Subject: MHI's Response to US-APWR DCD RAI No. 524-4020 Rev. 1

Response to Request for Additional Information
No. 524-4020 Revision 1

RAI NO.: NO. 524-4020 REVISION 1
SRP SECTION: 12.03-12.04 – Radiation Protection Design Features
APPLICATION SECTION: 12.3
DATE OF RAI ISSUE: 1/26/2010

Figure 1 Dose calculation model of spent resin transfer line for MicroShield code
(Source Activity: Values from Table 12.2-48 of the US-APWR DCD Rev.2)

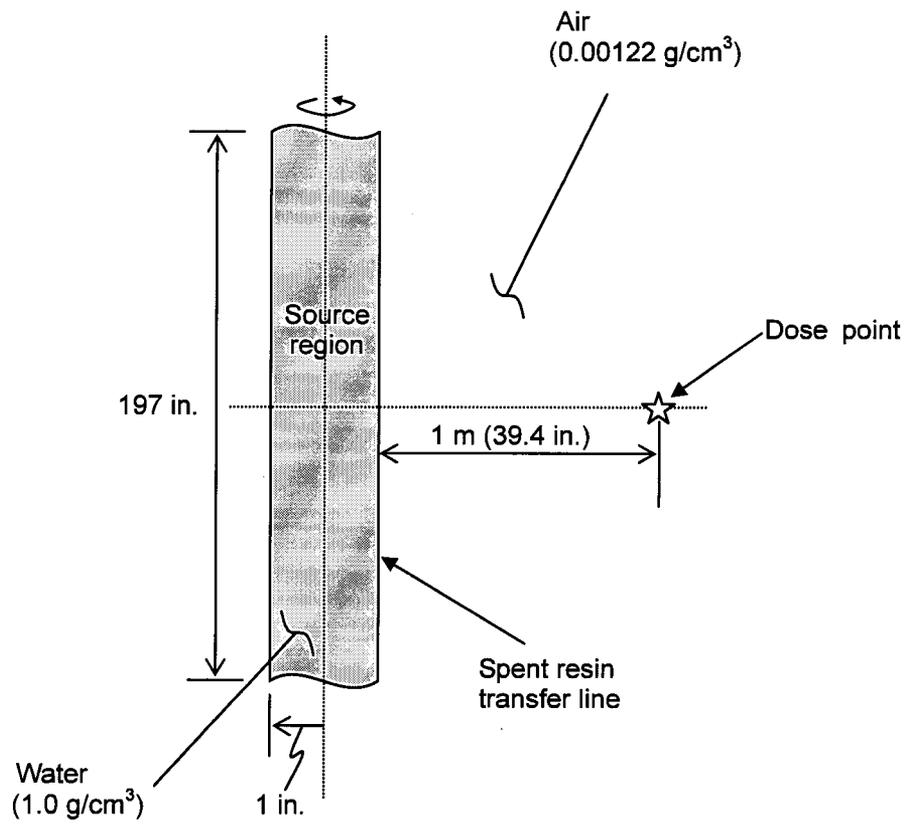
RAI 428-2910, Question 12.03-12.04-22 (a supplemental question derived from RAI 171-1858, Question 12.03-12.04-9 and RAI 172-1864, Question 12.03-12.04-10), requested additional information about the radiation protection features associated with the additional penetrations in shield walls located in some of the piping areas depicted in Figure 12.3-1 included in the response to RAI 172-1864. In their response, the applicant noted that some resin transfer lines ran through areas that were contiguous with areas containing valves. The piping rooms were assigned Radiation Zone IX < 500 rad/h. However, confirmatory calculations performed by the NRC staff using some of the isotopic concentrations provided in FSAR Tier 2 Table 12.2-17 indicate that dose rates could exceed 500 rad/h at one meter from a 2" pipe 90 degree elbow containing resin, even after a year of decay in the mixed bed vessel. The NRC staff requires additional information to be able to confirm the applicant's conclusion that dose rates in the piping areas will remain < 500 rad/h during resin transfers.

The applicant should provide information regarding the analytical code used to evaluate the dose rates in areas traversed by resin lines, the assumptions and input parameters used to determine the area dose rates due to pipes containing resin described in the response to RAI 428-2910.

The radiation zone in the piping area including the resin transport piping was determined based on a MicroShield dose rate calculation using the SRST resin as the source of the radioactivity of the piping. The calculated dose rate at 1 m from the pipe surface is 185 rad/h, which meets the dose conditions of Radiation Zone IX. The specific geometric and material-related calculation conditions used in MicroShield are provided in the attachment.

Figure1 Locations of the Containment Racks

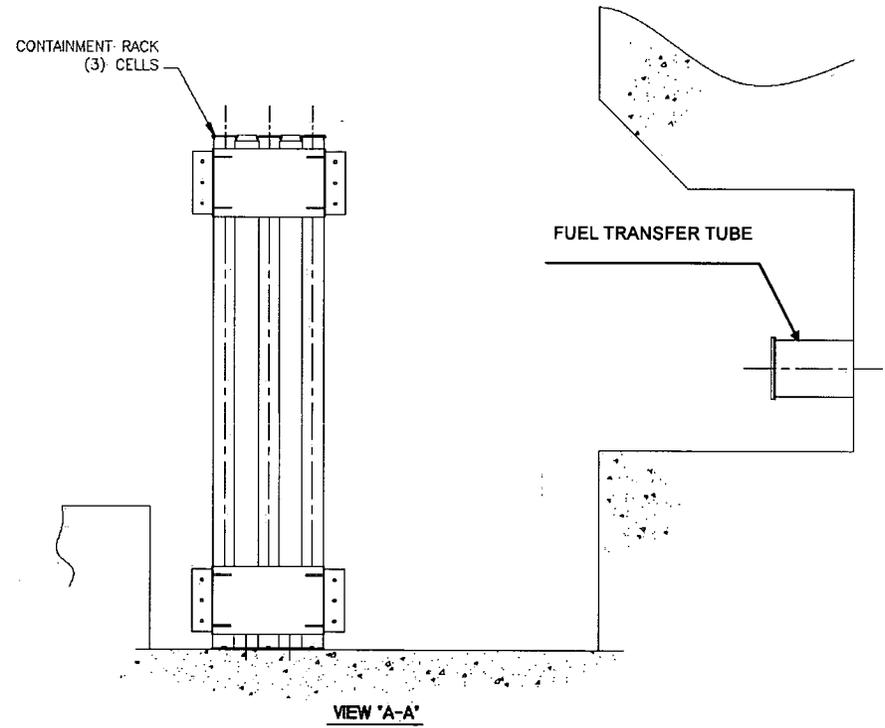
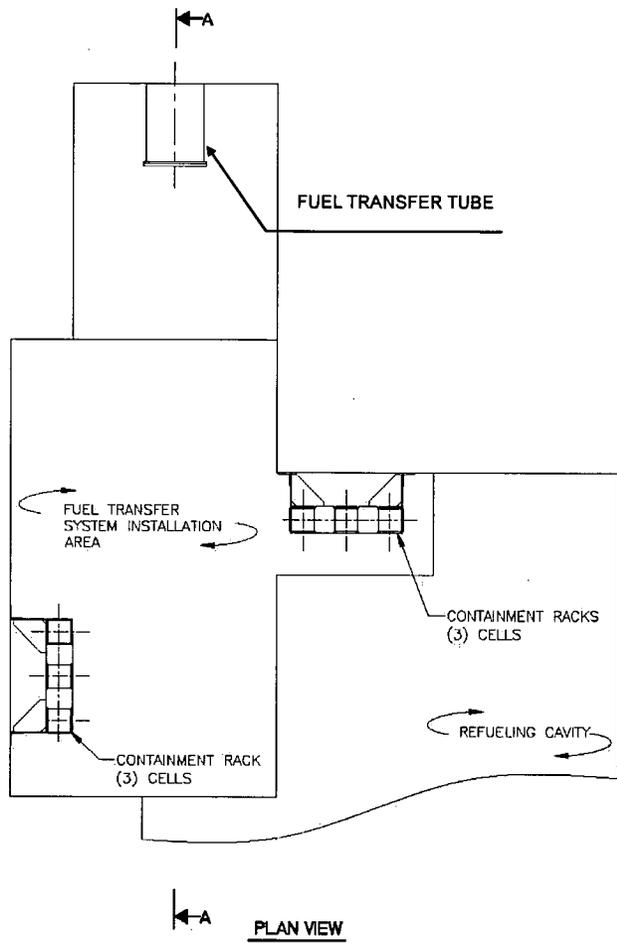
1. Identify any locations in the Refueling Cavity, where more than one fuel bundle, including any in transit, may be out of the reactor vessel in the Refueling Cavity.

2. Provide information on each location in the refueling cavity, where a licensee could safely store a spent fuel assembly should the reactor cavity undergo inadvertent rapid drain down while one or more fuel bundles were out of the reactor vessel in the refueling cavity.

1. The refueling cavity has two fuel containment racks that are capable of storing three fuel bundles each, meaning that a total of six fuel bundles can be temporarily stored. The locations of the containment racks are shown in Figure 1. These fuel containment racks are installed for the following purposes:
 - 1) To temporarily store dummy fuel to be used during fuel loading
 - 2) To temporarily store fuel
 - As a standby for returning the fuel handling system from the fuel handling area; and
 - For use if there is any problem with the fuel handling system when transferring fuel with the refueling machine.
